Re: Contract No. 200-2004-03805, Task Order 5: Transmittal of Draft SCA-SEC-TASK5-0056, Revision 1, *Review of the Feed Material Production Center (FMPC) Special Exposure Cohort (SEC) Petition-00046 and the NIOSH SEC Petition Evaluation Report*

*Review of the Feed Materials Production Center (FMPC)  
Special Exposure Cohort (SEC) Petition-00046  
and the NIOSH SEC Petition Evaluation Report*

**Contract No. 200-2004-03805  
Task Order No. 5  
SCA-SEC-TASK5-0056, Rev. 1**

### Figure 4.3-1. Comparison of Lapel to Fixed Station Air Sampling

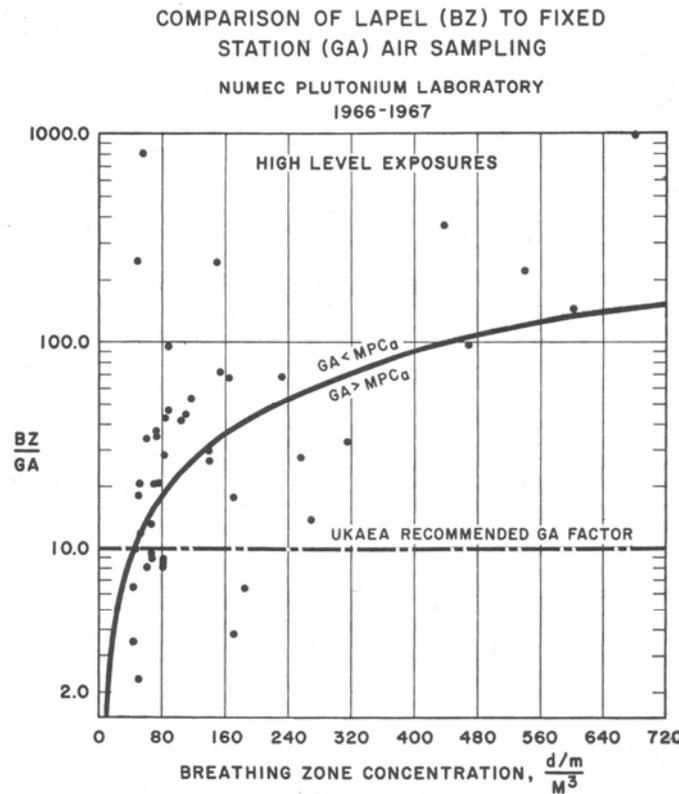
**Finding 4.3-1: Generic Limitations and Uncertainties Associated with Air Sampling for Monitoring Worker Exposures**

There are two basic kinds of air sampling strategies used to monitor worker exposure: fixed station, commonly called general area (GA) sampling, and breathing zone (BZ) sampling. Because sources of airborne contamination are highly localized, concurrent measurements by GA and BZ frequently differ by orders of magnitude.

In a 1967 study conducted at the Nuclear Materials and Equipment Corporation (NUMEC), BZ lapel air sampling measurements were compared to GA samples. Figure 4.3-1 illustrates the strong tendency of GA samples to underestimate the air concentrations to which a worker is exposed. Important to note is that this discrepancy increases with air concentrations and at the MPC level is on average about 70-fold too low (see Figure 4.3-2).
